County of Santa Clara

July 3, 2023

FILE NUMBER: PLN23-010
SUBJECT: Building Site Approval, Design Review, and Grading Approval for a Single-Family House and a Prefabricated Barn.
SITE LOCATION: 10818 Crothers Rd, San Jose, CA 95127 (APN: 612-44-033)
DATE RECEIVED: June 05, 2023

Your application for Design Review and Grading Approval for a prefabricated barn received on the above date is deemed **incomplete**. For the application processing to resume, you must resolve the following issues and submit the information listed below.

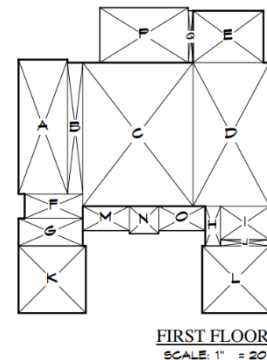
1. The enlarged site plan is included but an overall site plan is not included in the plan set for review and is incomplete. Please provide an overall site plan with complete boundaries and all easements of the subject parcel, and identify the following items:
 - a) Locations of all proposed structures, including the main house with attached garage, detached storage, and detached prefabricated barn.
 - b) Front-, side-, and rear-yard setbacks, and distances to property lines.
